GeoResources, LLC
5007 Pacific Hwy. E, Suite 16
Fife, Washington 98424-2649

October 6, 2017

Geotechnical Report Addendum and
Statement of Risk
Detached Garage
3603 West Mercer Way
Mercer Island, Washington
Parcel No: 3623500260
Doc ID: FatBoyCon.WMercerWay.RGA(1)

Lateral Earth Pressures
Proposed Single Family Residence
3603 West Mercer Way
Mercer Island, Washington

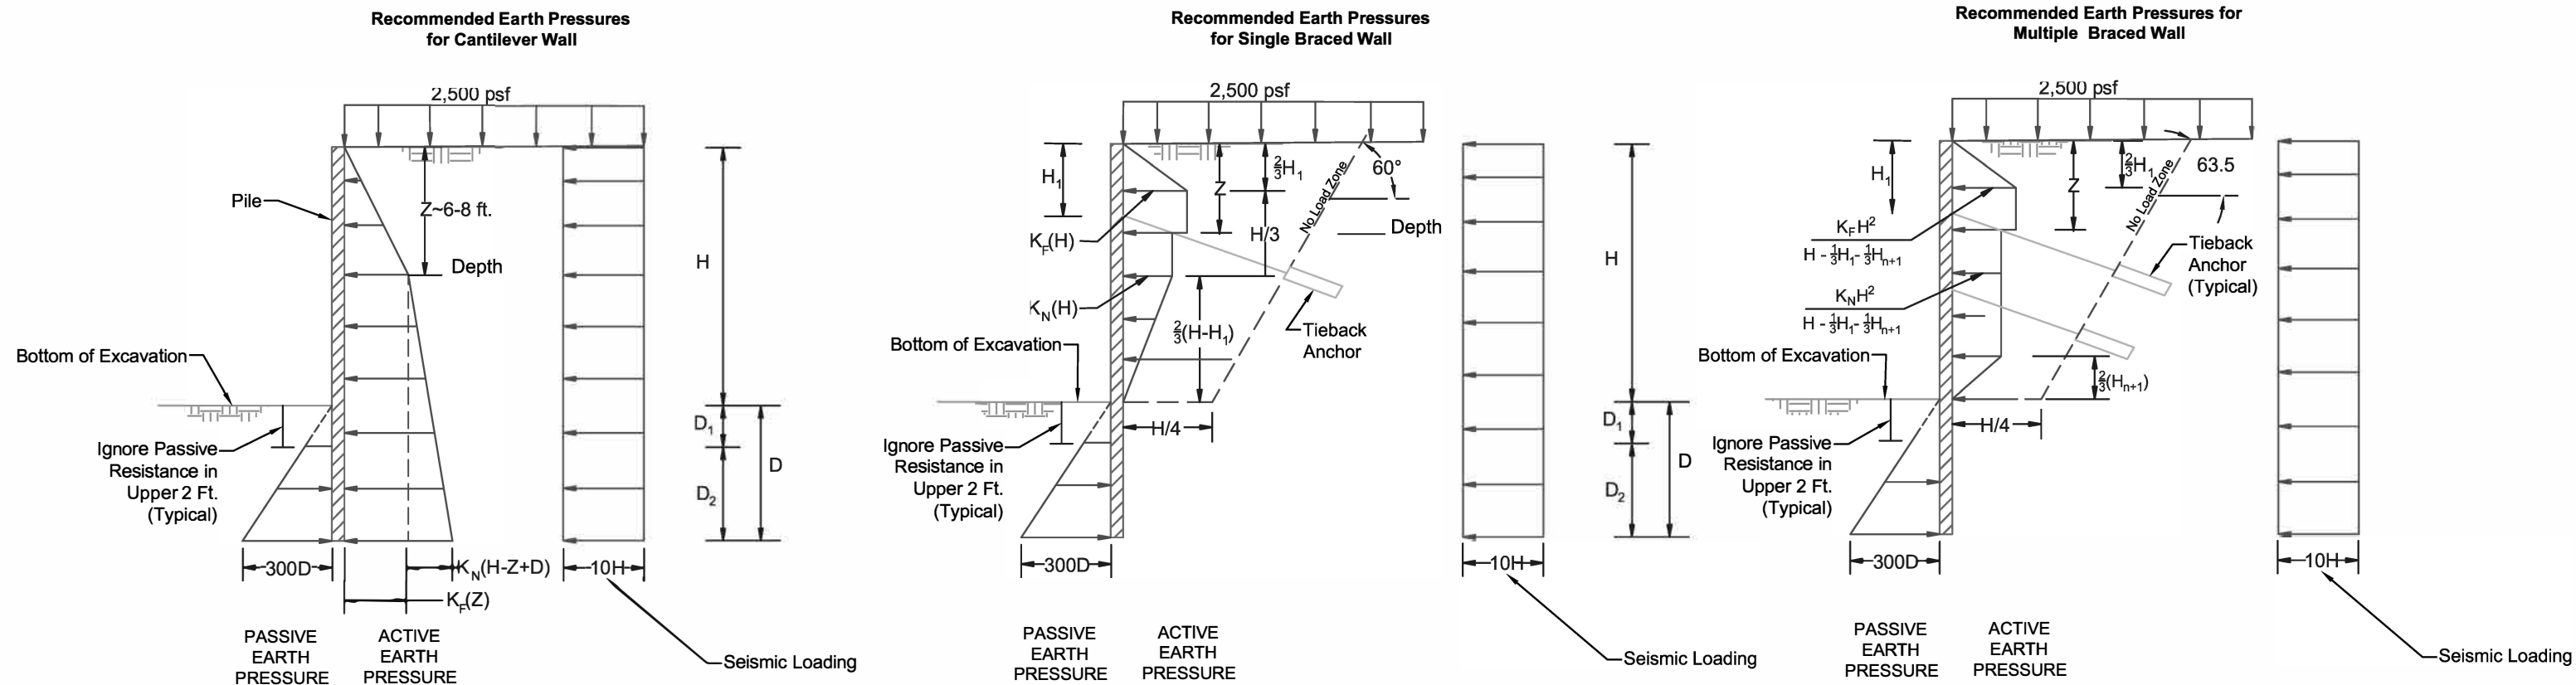
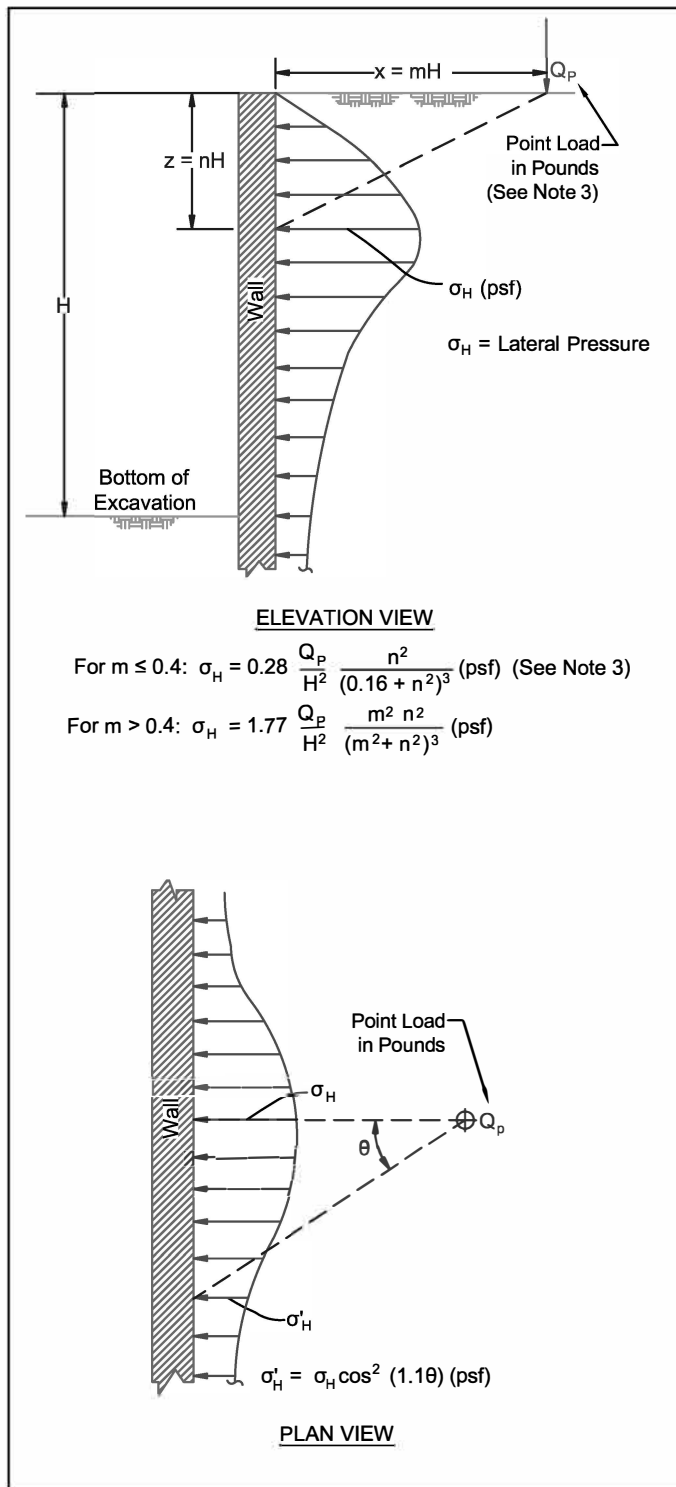
Design of the below grade structures may be performed using the earth pressures and loading diagrams provided in Figures 1 and 2. A 2,500 psf surcharge was used to model the slope above the main cut. This should only be applied in this area. A seismic surcharge is provided based on the IBC seismic coefficient and the Mononobe-Okabe analysis. This surcharge should be applied uniformly as required by the code.

We understand a portion of the upper part of the garage will be designed and constructed using geofoam to reduce the loads on the slope and the structure. We recommend an equivalent active fluid pressures of 3 psf be used for the geofoam. Where geofoam is used below areas that will have parking a geomembrane should be utilized to prevent fuel spills from reaching the foam and causing the foam to disintegrate.
